P 3678
A Repair

SEWAGE DISPOSAL SYSTEM

MARYLAND STATE DEPARTMENT OF HEALTH

ADDRESS 14010 Forsythe Road, Sykesville, Md. PHONE 442-2416

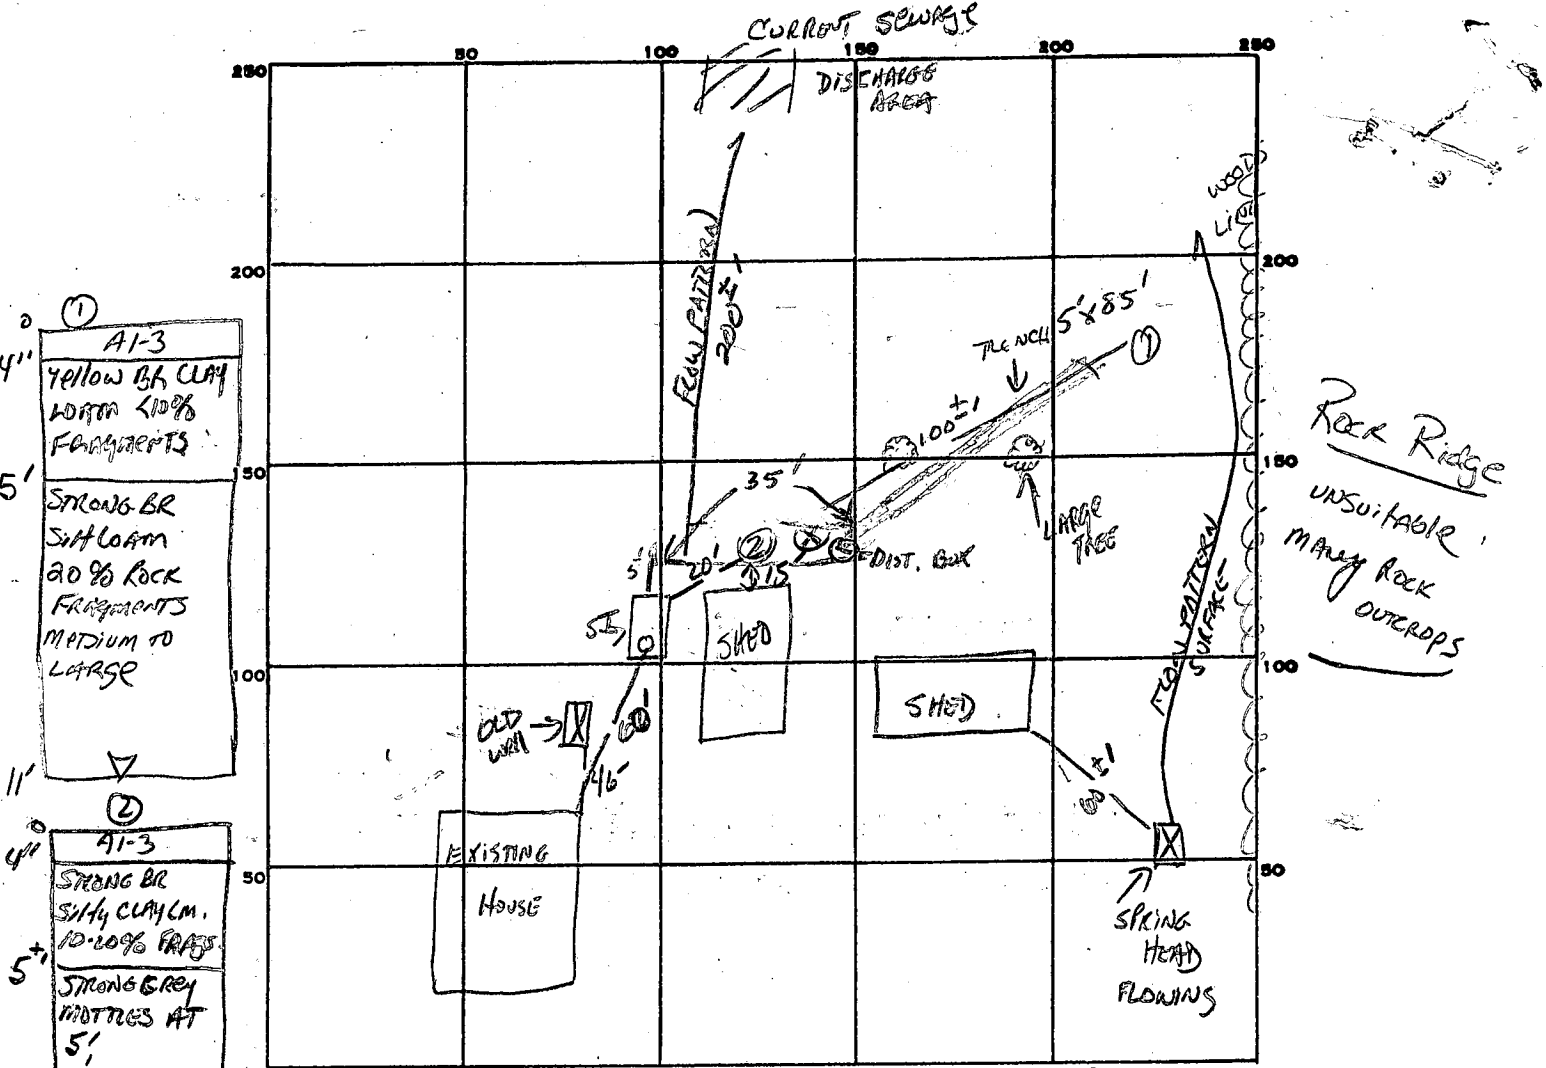
5-1-86 - SHALLOW SYSTEM- INLET 4'-5' below GRADE; BOTTOM S.S-
6.5' below GRADE; 12"-18" STONE below PIPE; NEED MINIMUM 88 FE
TRENCH 5' WIDE; RUN TRENCH FROM BEHIND SPRING HOUSE (R) TOWARD
HOLE #1 between LARGE TREES. IF UNABLE TO MEET MAX INLET DEPTHS
will require PUMP SYSTEM. S. Add

SPRING NEAR TANK NOT CONNECTED TO ANY WATER SUPPLY. YARD CONTAINS
SEVERAL SPRINGS. C.W.

REMARKS NO EXISTING SYSTEM - STRAIGHT PIPE DISCHARGE TO REAR OF PROPERTY, CW

SHED CLOSEST 4-11-03
TO SEPTIC TANK
IS NOW GONE,
SAYS Mr. Measmer.
THE SITED CLOSEST
TO SPRING still
exists
KN
